Preliminary Drainage Report

**For the Dos Lagos Lot 'E'
Parcel Number: 0419106028
405 39th Ave SE
Puyallup, Washington**

**May 2021
Revised August 2023
Revised March 2024
Revised September 2024
Job No: 12896**

Project Name: Dos Lagos Lot ‘E’ Project
Permit Type: Multi-Family Residential
Permit No: P21-0100
Site Address: 405 39th Ave SE, Puyallup, WA 98374
Parcel Numbers: 0419106028

DOS LAGOS – LOT E (LSE 12896) MR7 STORMWATER CALCULATION INCLUDING ONSITE AND OFFSITE

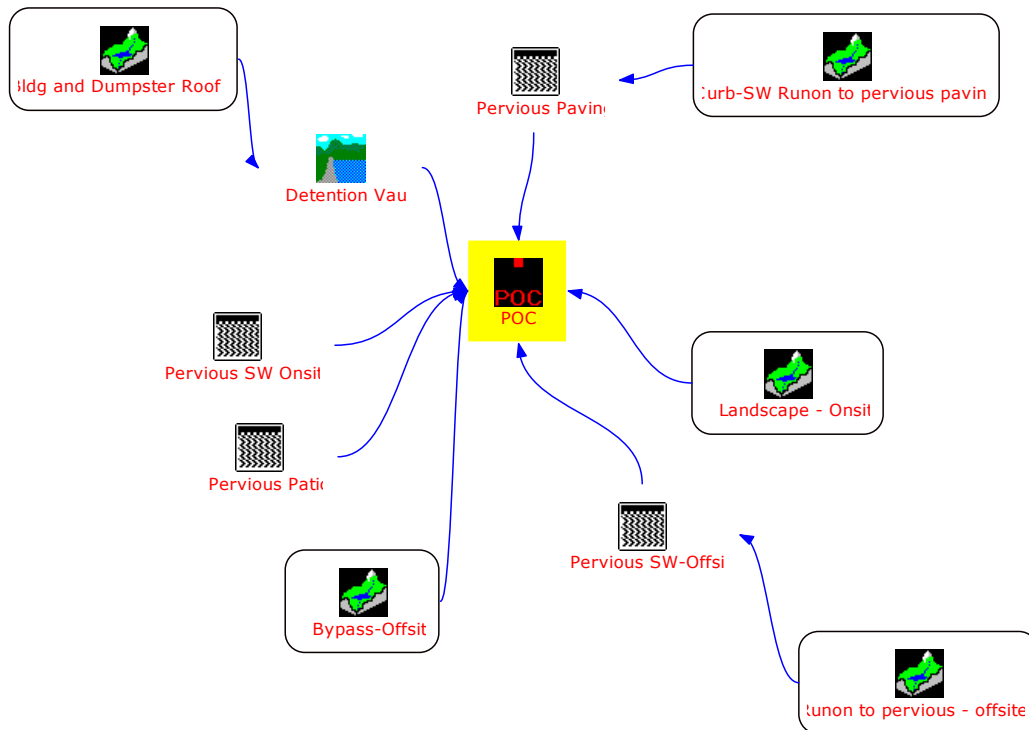
CONDITION: At time of civil application, provide additional commentary regarding Ecology's run-on limitations, bullet-points 1 and 2 on Page 748, Chapter 5, Volume 5.

**DOS LAGOS – LOT E (LSE 12896)
MR8 STORMWATER CALCULATION WILLOWS POND BASIN
INCLUDING ONSITE AND OFFSITE IMPROVEMENTS
PREDEVELOPED**

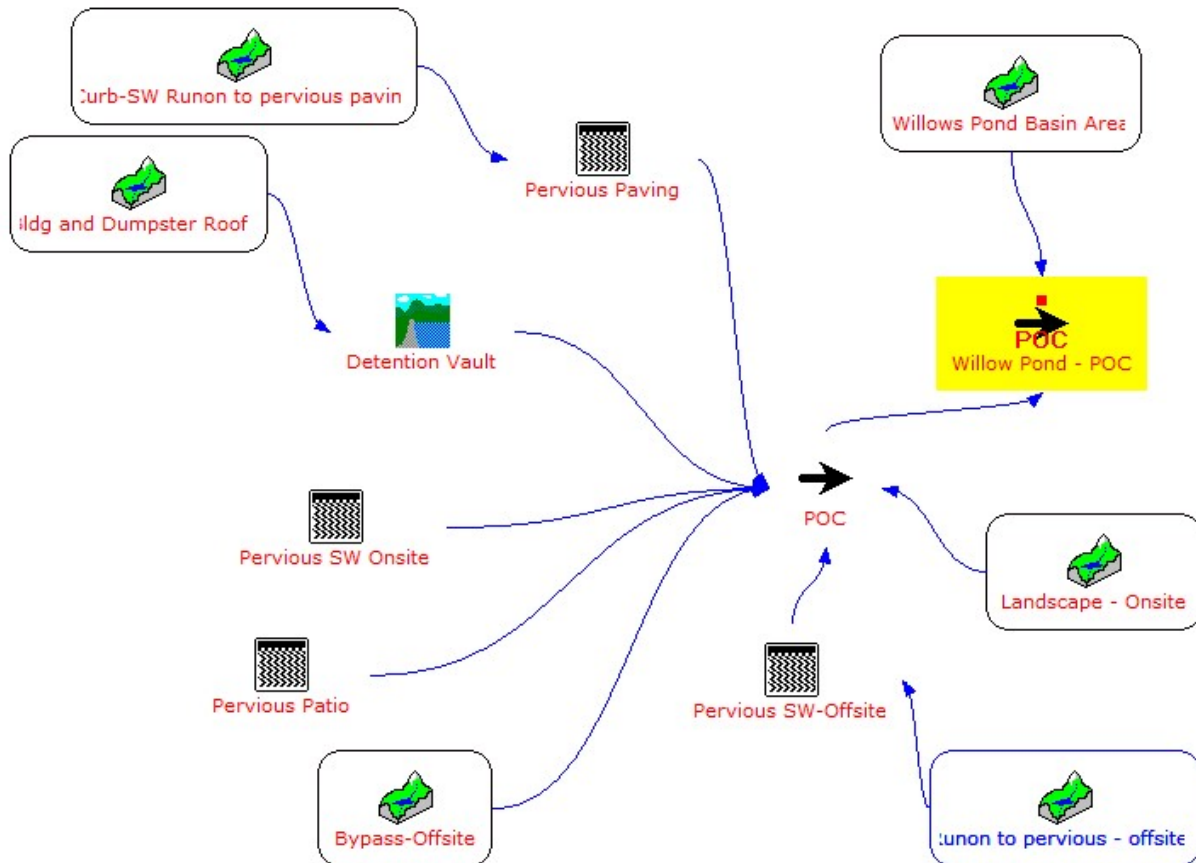
The city just received a 3rd party consultant confirmation for Willows Pond which categorizes the wetland as **Category III**, with a **Habitat Score of 4**. This means that the MR8 analysis can use Method 2 (versus my prior review comment concerning Method 1). The Planning Dept is checking whether the pond supports "rare, endangered, threatened, or sensitive species; or a breeding population of any native amphibian" which would determine whether the hydroperiod is required...although you have already completed the analysis.
